TECHNICAL ADVISORY REPORT

IN SUPPORT OF THE JOINT LETTER OF INTENT
FOR TATA STEEL NETHERLANDS

Date of publication: 29 September 2025

Figure 9. Predicted CO₂ emissions per (sub)project [6]

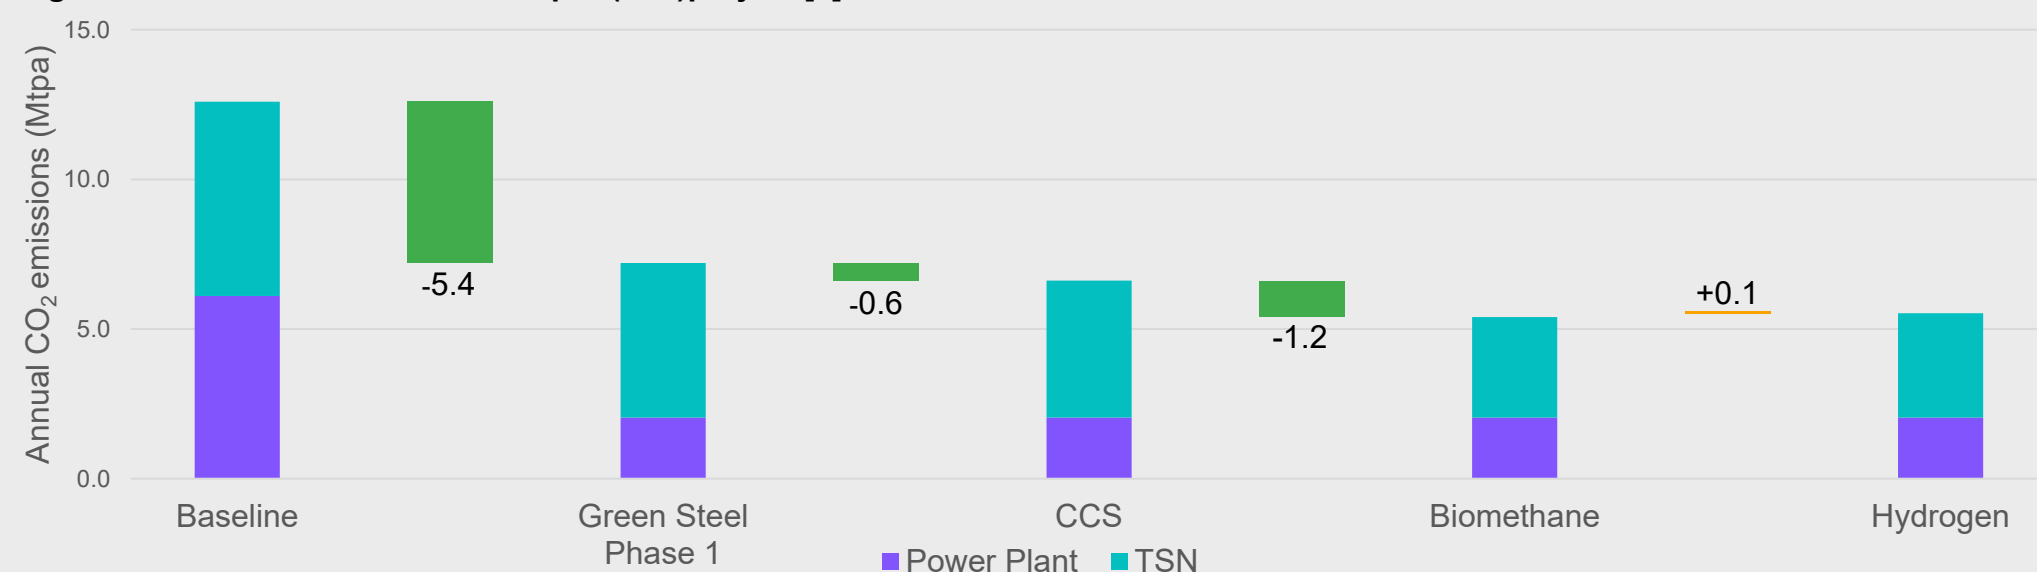
To calculate CO₂ emissions, TSN uses its in-house Carbon (reduction) Selection Model (CSM) which is based on carbon mass-balance principles and historical data for the existing assets. The material flows for the new assets (DRP-EAF) are sourced from databooks provided by the Original Equipment Manufacturers (OEMs). Overall, the methodology is considered appropriate and in line with industrial best practice. However, some uncertainties are identified:

- Only the major assets onsite are included.
- Minor carbon flows (e.g. scrap and steel products) are excluded.
- Only CO₂ is included; other greenhouse gasses are omitted.
- The coking time of CGP1 will increase once Green Steel Phase 1 is implemented. This operational change can impact the material balance over CGP1, but is not completely reflected in the calculations.
- Some consumption factors in the CSM differ from source documents.

A margin of 0.6 Mtpa has been agreed upon in the JLoI. This margin is considered sufficient to allow for any of the above-mentioned uncertainties to materialise. Therefore, it is likely the stated CO₂ objectives in the JLoI can be achieved with Green Steel Phase 1. The scope of this review only covers scope 1 emissions, scope 2 and 3 emissions are specifically not part of this review.

Figure 11. TSN's predicted PM₁₀ immission contribution reductions in WaZ [6]

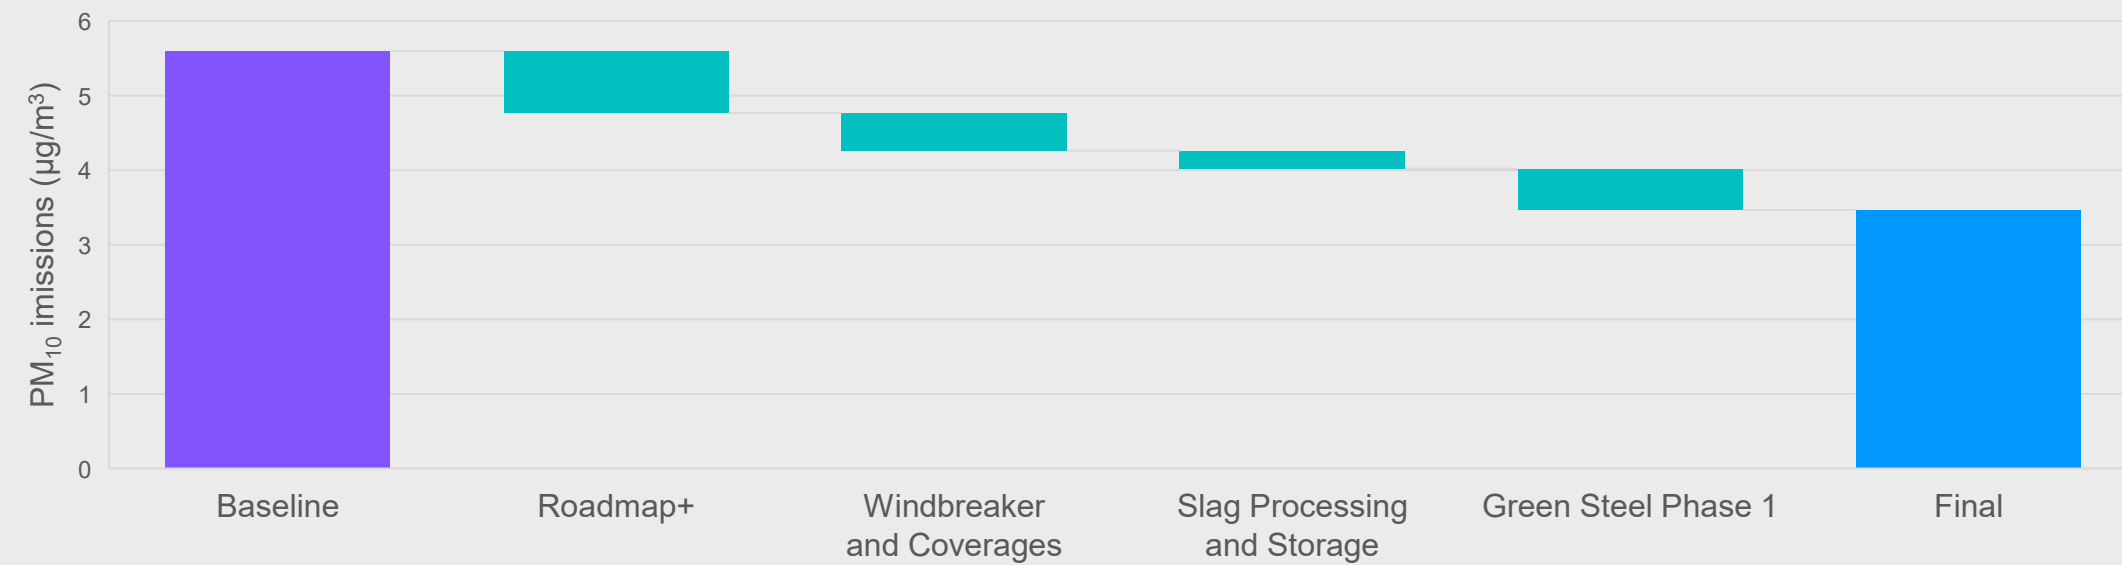
TSN estimates its 2019 baseline immission contribution in WaZ at 5.6 µg/m³, including chain partners Harsco and PHY. To meet the 35% target, a reduction of approximately 2.0 µg/m³ is required (Figure 11). TSN predicts a 38% reduction (2.1 µg/m³) through combined measures (reduction percentages and totals may differ due to rounding):

The PM₁₀ immissions have been calculated using TSN's emissions data and dispersion industry-standard dispersion modelling software. While this approach aligns with industry best practice, and dispersion modelling is the appropriate tool for predicting future immissions, this introduces additional uncertainty such as not being able to predict future meteorological conditions and how the model calculates pollutant dispersion. Independent baseline immissions estimates by RIVM, derived from alternative modelling and monitoring data analyses, range from 4.6 to 7.4 µg/m³. TSN's baseline immission estimate of 5.6 µg/m³ falls within this range. However, the spread of values highlight the inherent uncertainty in immission modelling.

Uncertainties were identified, that are partly inherent to PM₁₀ calculation, however this may result in falling short of the reduction target.

Figure 12. PM₁₀ immission reduction in WaZ from the Windbreaker and Coverages [6]

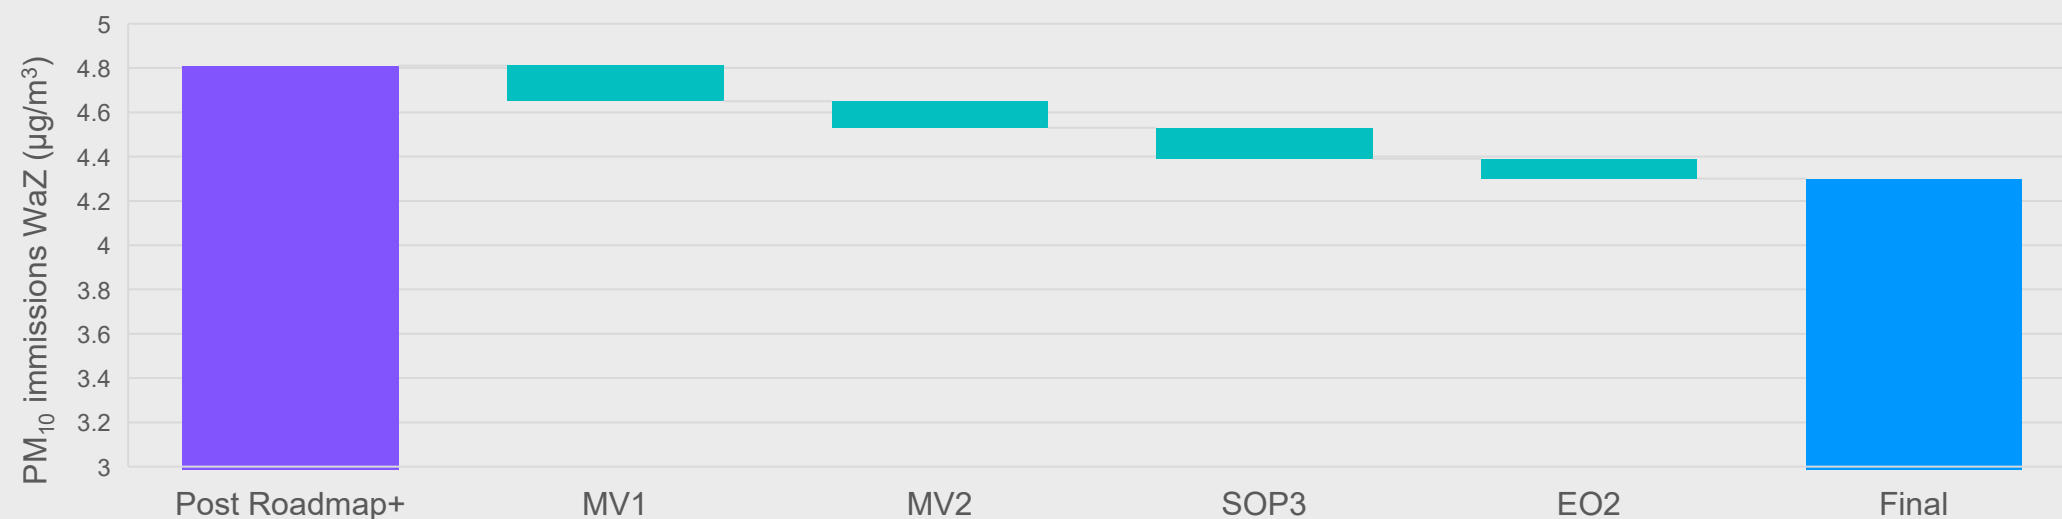
Measures include a windbreaker at MV1 and coverages at MV2, EO2, and SOP3. These are predicted to reduce PM₁₀ immissions by ~0.5 µg/m³ (~9%) (see Figure 12). As detailed on page 15, TSN's calculations have used emission factors from national guidance and dispersion modelling by an independent consultant. Reduction factors applied (90% for full coverages and 50% for the windbreaker) are supported by published literature and wind simulation data. This methodology aligns with industry best practice, however the predicted reductions are subject to uncertainty due to the cumulative effects of:

Figure 18. Two Water Granulation Concepts [16]

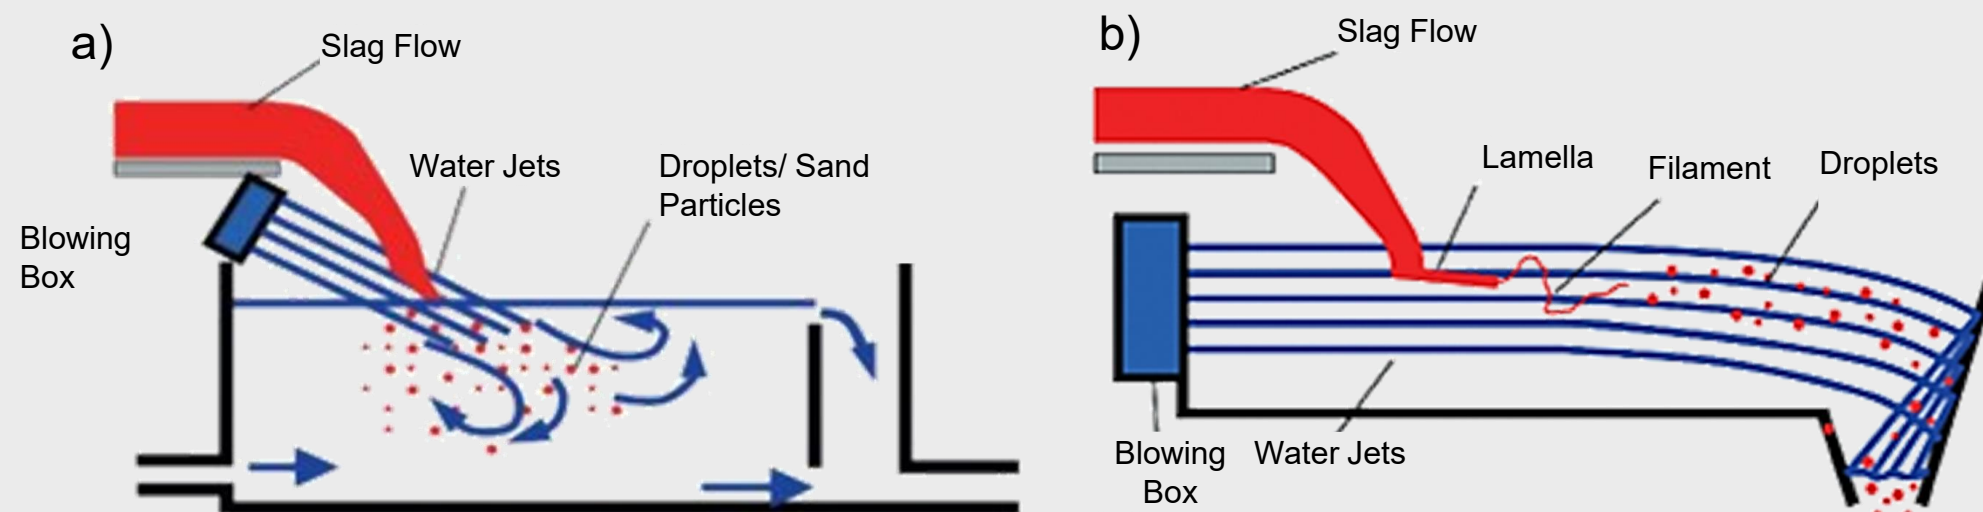
TSN has selected water granulation as the preferred processing method after evaluating alternatives. This process rapidly cools molten slag with water jets to form glass-like granules (Figure 18). TSN currently uses water granulation for blast furnace slag, which is widely used as SCM.

Future regulatory changes on heavy metals could significantly impact the viability of slag applications. TSN has acknowledged that stricter limits on chromium and vanadium could pose a major challenge.

TSN's slag processing and application plan is in early stages of development. The current plan relies on a technology and application pathway that is not yet proven at the required scale. Significant challenges and uncertainties remain regarding technical feasibility, certification, and environmental compliance. A clear and detailed development roadmap, supported by OEM commitments and independent testing, will be essential to reduce these uncertainties. Due to the uncertainties with water granulation, TSN is engineering quench cooling as fallback option, which is considered a more proven technology, although challenges with SCM application remain.

Figure 19. Phase-by-Phase and Total CapEx for Green Steel Phase 1 [6]

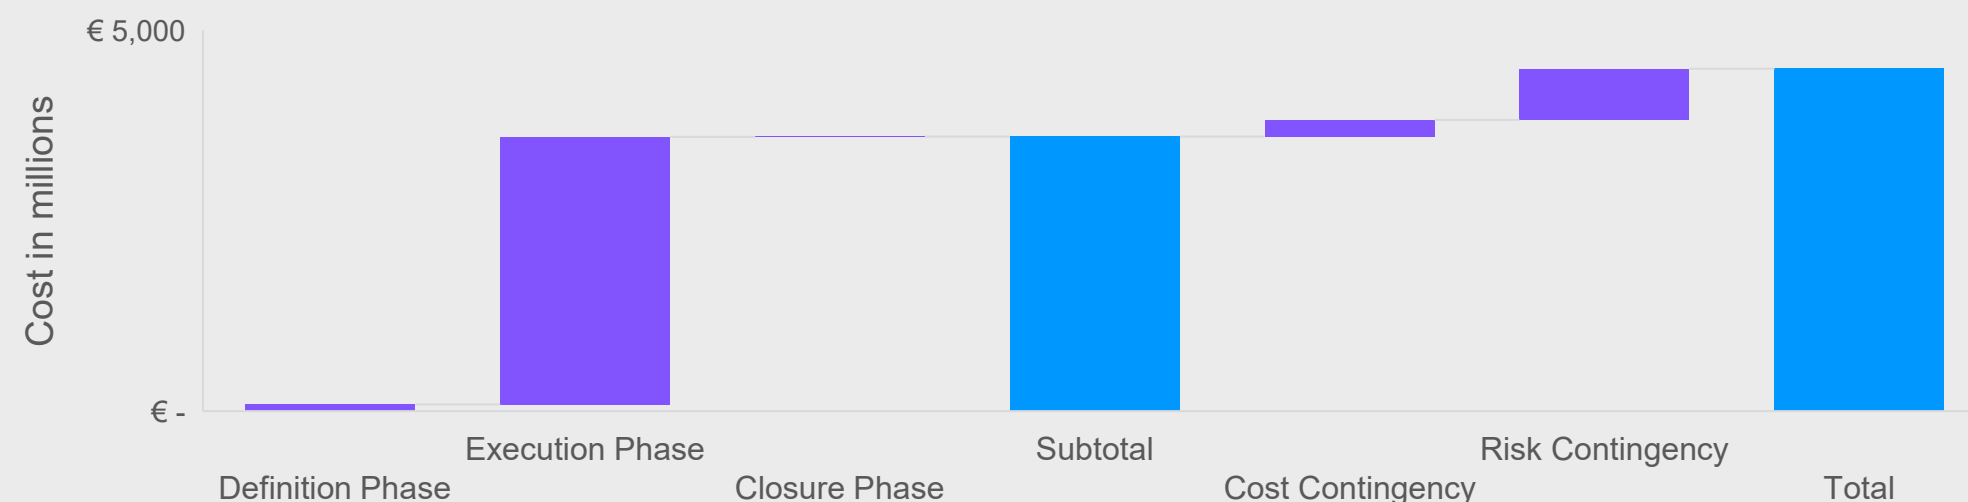
TSN's total CapEx allowance for Green Steel Phase 1 is approximately €3.6 billion, excluding contingency and risk provisions. When these are included, the total rises to around €4.5 billion. The estimate is structured across three phases (see Figure 19):

- **Cost contingency:** TSN has included 6%, which is considered low given the level of definition. A contingency of ~10% would be more appropriate.
- **Risk contingency:** Currently 19%, based on an outdated risk assessment, but considered broadly reasonable.

Figure 20. CapEx estimate Windbreaker and Coverages [6]

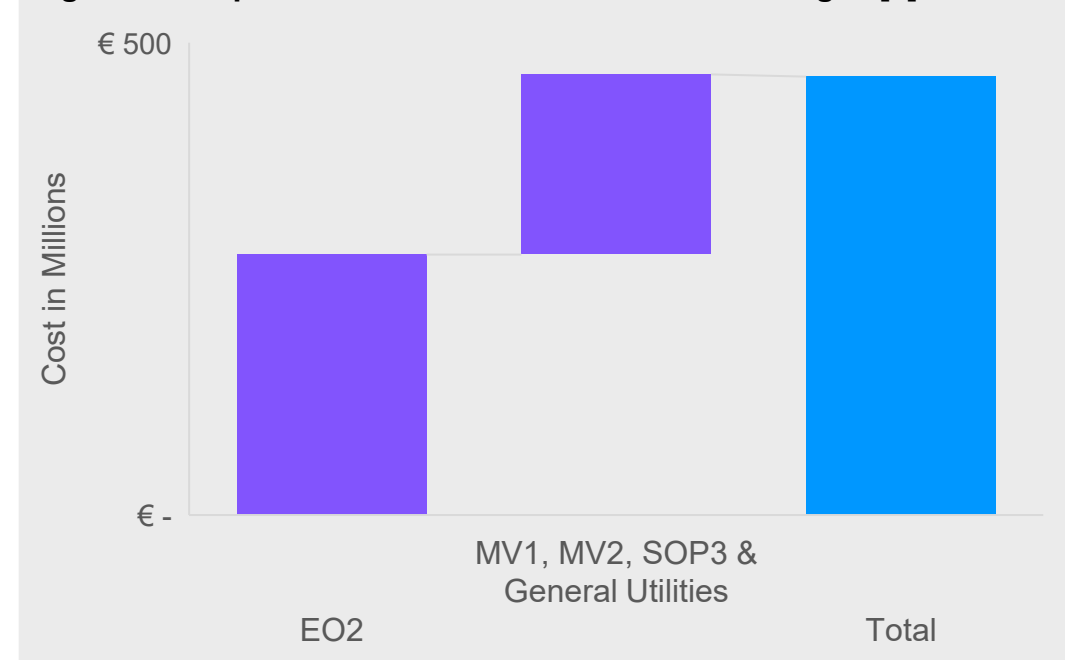
TSN's total CapEx allowance for the Windbreaker and Coverages project is approximately €465 million, divided across four main storage areas (EO2, MV1, MV2, SOP3) and General Utilities (Figure 20). The estimate is structured as follows:

EO2 accounts for 60% of total project costs (~€275 million) and is at FEL1/2 maturity. Current contingency is 17%, which is low given the early stage and identified issues. A contingency of 25% is considered more appropriate. As this estimate accounts for 60% of the total programme costs, this significantly affects the total integrity of the cost estimate.

Figure 21. Accuracy of the CapEx estimates per asset [6]

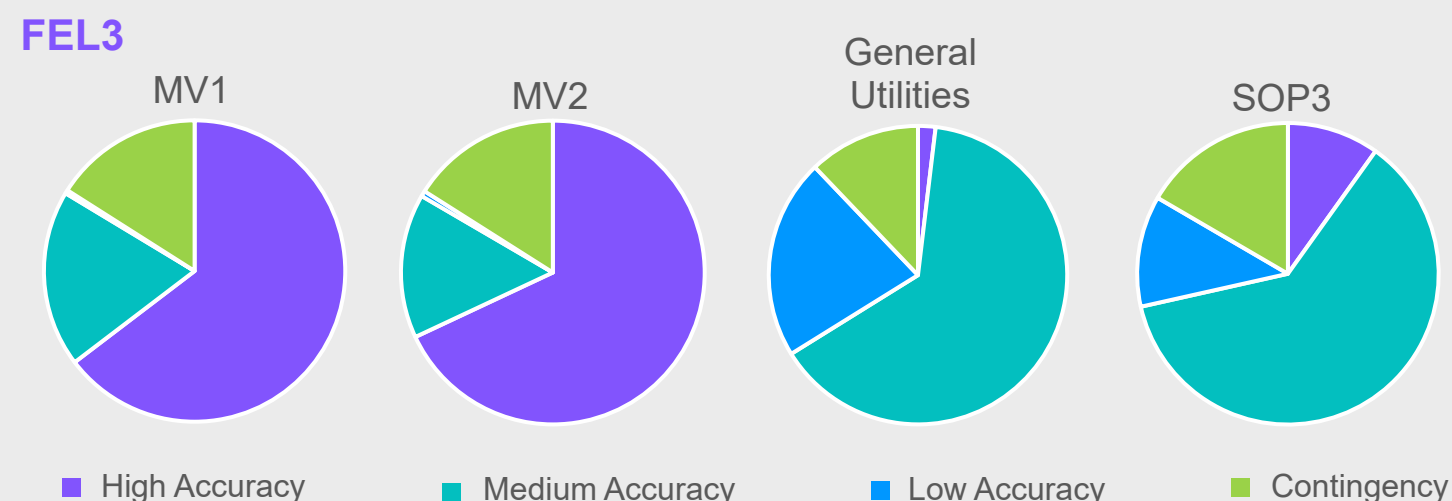
- **MV1 and MV2:** Data accuracy is medium to high (Figure 21), supported by budget quotes and benchmarks.
- **SOP3 and General Utilities:** Data has a lower accuracy, with limited breakdowns and reliance on in-house estimates. No detailed breakdown was provided for project management office costs, which introduces uncertainty.
- **Contingency:** for general utilities is lower than for other areas, despite higher uncertainty.

Figure 22. Total CapEx Slag Processing and Storage [6]

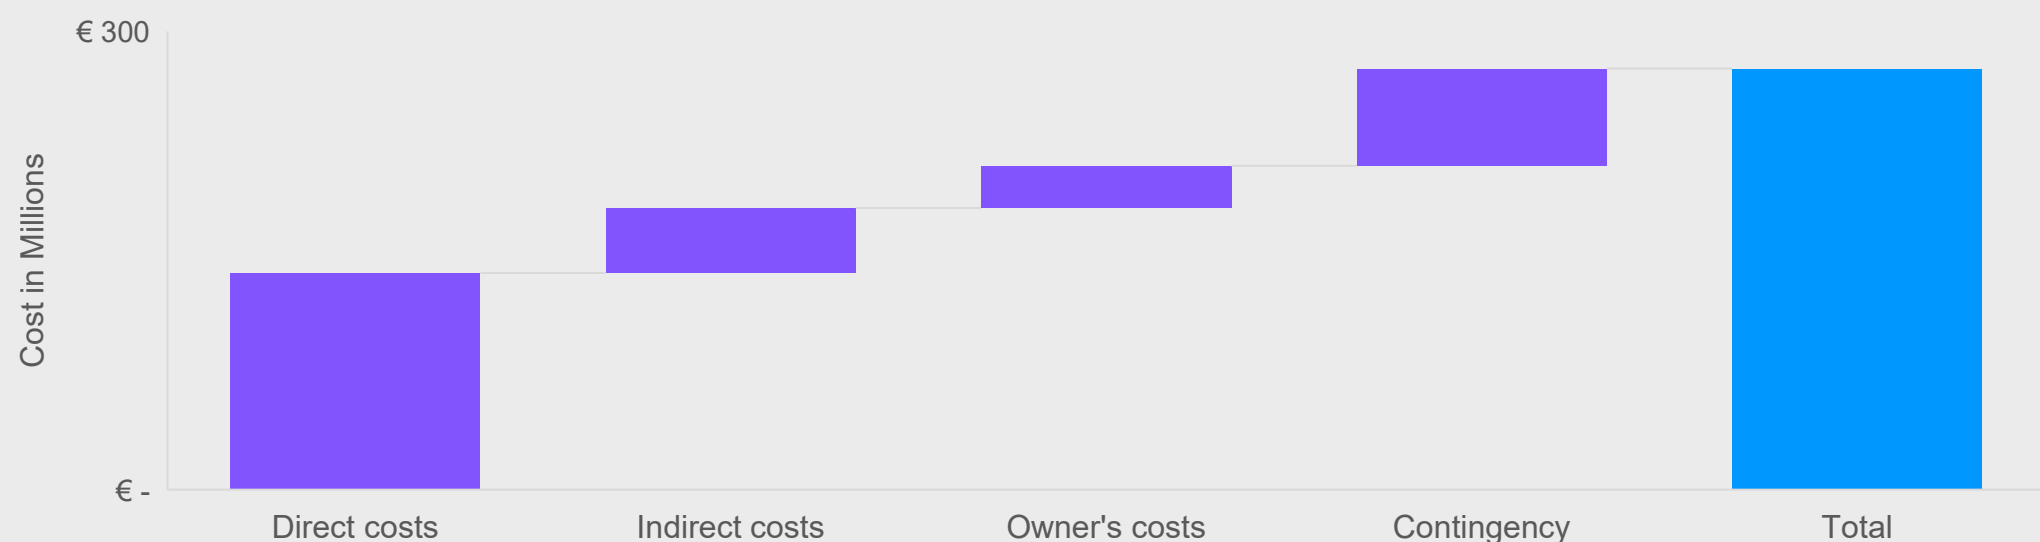
The estimate uses historical data from similar systems. The proposed flow rate is 500,000 m³/h, with the estimate scaled down from larger reference plants. The approach is considered reasonable.

A contingency of 30% is applied to the total estimate. This is in line with expectations for FEL1 maturity.
